RFI #149: LSFS 4&5 - Tel/Radio Room UL Listing Clarification

Status	Open		
To	Rich Arave (GLMV Architecture) Edgar Flores (GLMV Architecture) Chad Bard (GLMV Architecture)	From	Andrew Calderwood (McCownGordon Construction, LLC) 850 Main Street Kansas City, Missouri 64105
Date Initiated	Oct 17, 2023	Due Date	Oct 20, 2023
Location	Fire Station 4 & 5	Project Stage	
Cost Impact		Schedule Impact	
Spec Section		Cost Code	
Drawing Number	A-410, A-103	Reference	
Linked Drawings			
Received From	Sub Job		
Copies To	Andrew Calderwood (McCownGordon Construction, LLC), Nate Henson, STSC (McCownGordon Construction, LLC), Chloe Huxol (McCownGordon Construction, LLC), Michael Morgan (McCownGordon Construction, LLC)

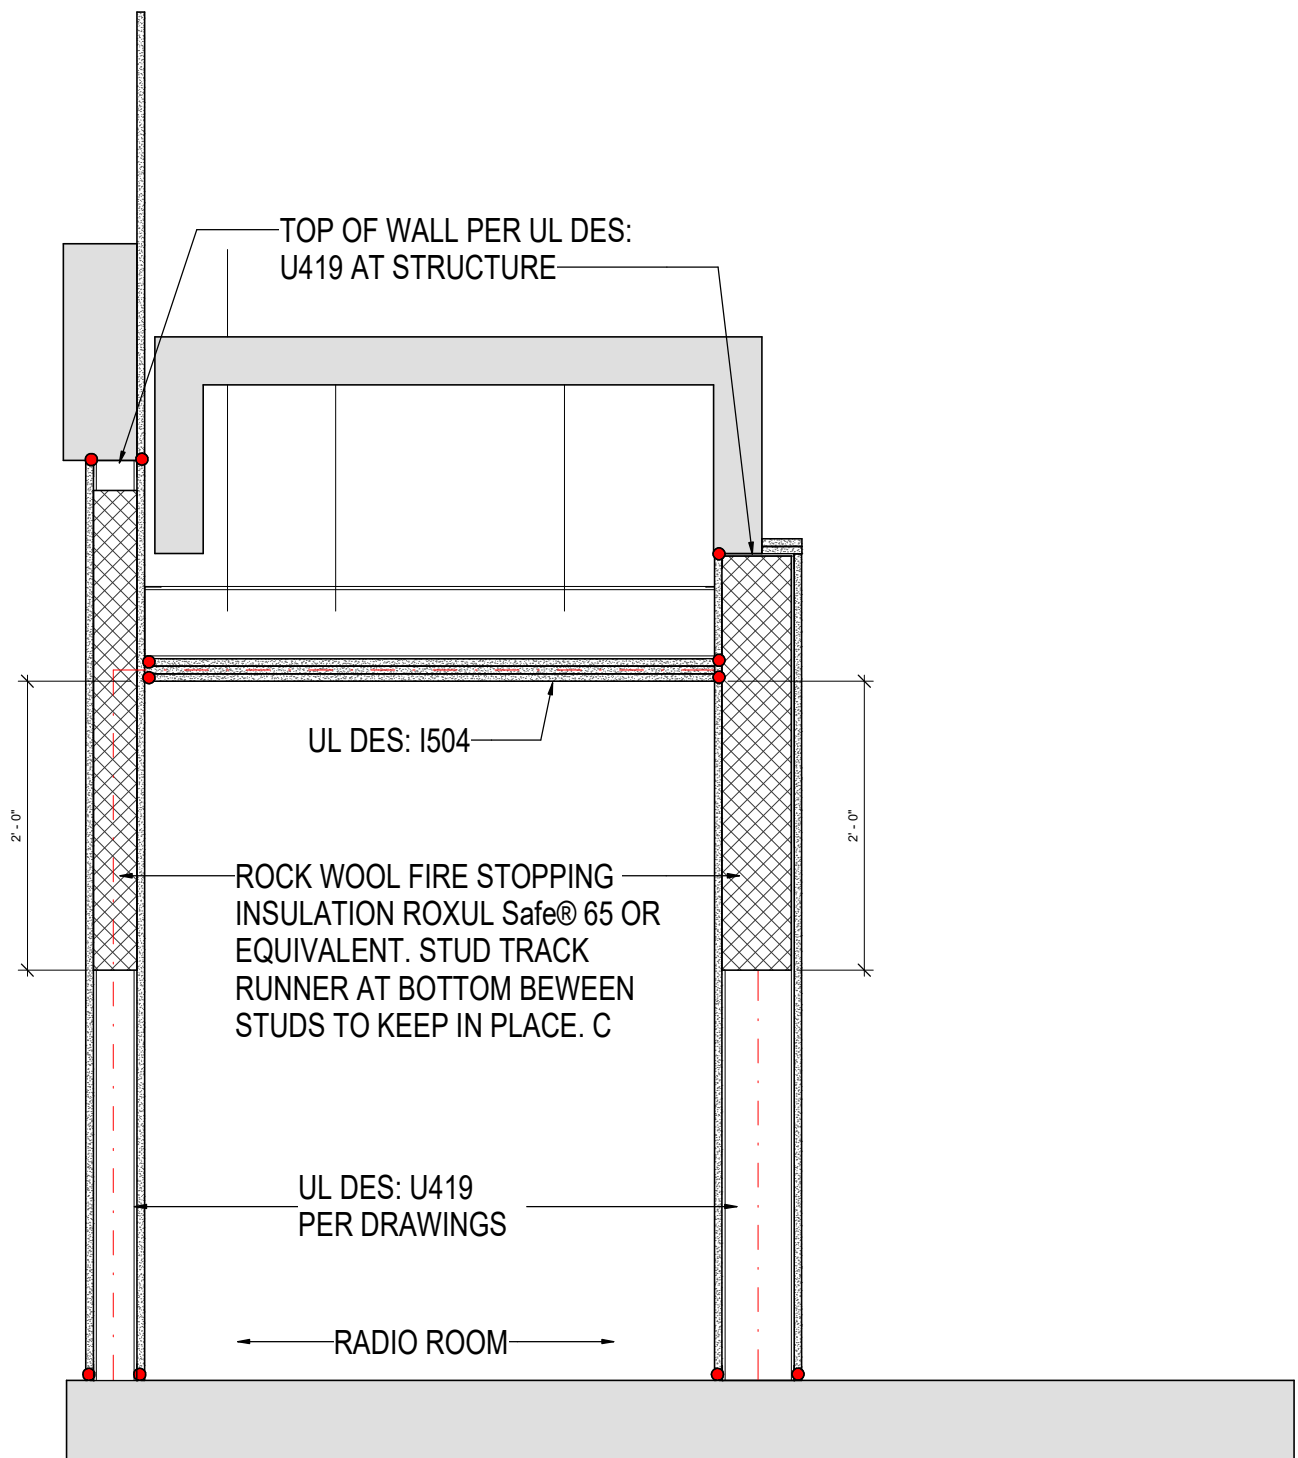
Please confirm that U419 called out for the Tel/Radio room walls is sufficient to achieve the necessary fire rating at these walls. Please note that at the wall under the middle stringer, the inside two layers of rock will extend up to the shower pans, but the layer on the outside of the wall will terminate at the wood sill called out in D4/A-410.

Please provide details for how the ceiling shown in A6/A-410 is to tie into the walls to achieve the 1 hour fire rating.

Refer to the image and email thread below for solution to this RFI.

WALL OPTION WITH EXISTING STUDS TO REMAIN.

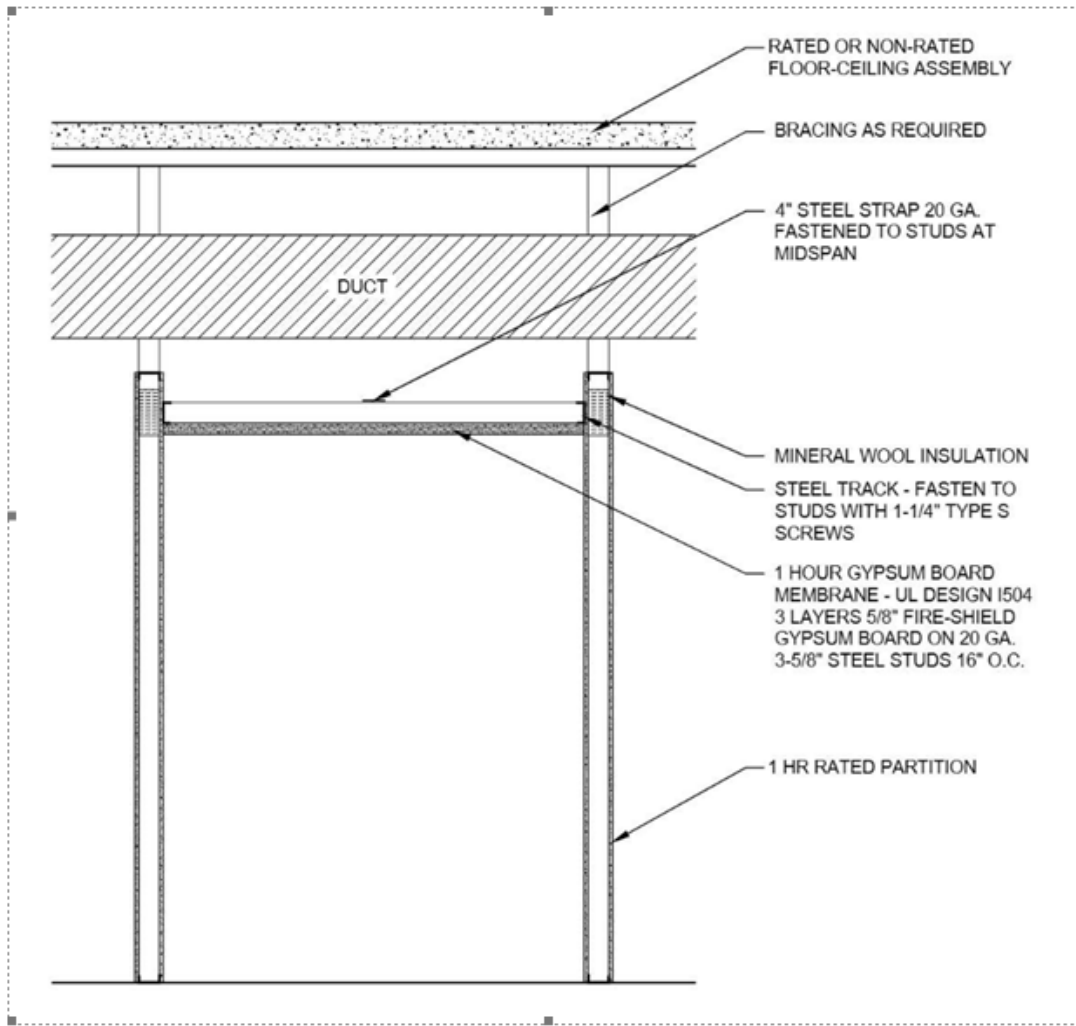
PCI brought up CR103 and asked if it would be possible to use this UL in our condition. It is on page 108 of the attached and snipped below. Looks a lot like what you sent before. What are your thoughts on this?

To be clear, we don't have any top of wall requirements that require interrupting the studs at the top of the first floor with a certain top track or anything right? Is there a required mineral wool depth?

This works for me. It doesn't appear different than the assemblies I sent to you and is functionally the same. This particular arrangement is intended for corridors where the wall doesn't go up to a roof, deck, or floor. Let's proceed with it. The mineral wool as I called out is the key component to continuity at the wall / ceiling transition. Thanks.

the top of wall is non load bearing in the UL Design. I don't see a UL callout for the wall used in the screen shot, but it appears that the top of wall track can happen above the fire rating line of the ceiling if the transition of fire stopped with mineral wool. The installation of the insulation is per manufacturer's written instructions for the desired rating, but full stud depth with non-combustible retention in the form of horizontal track between studs
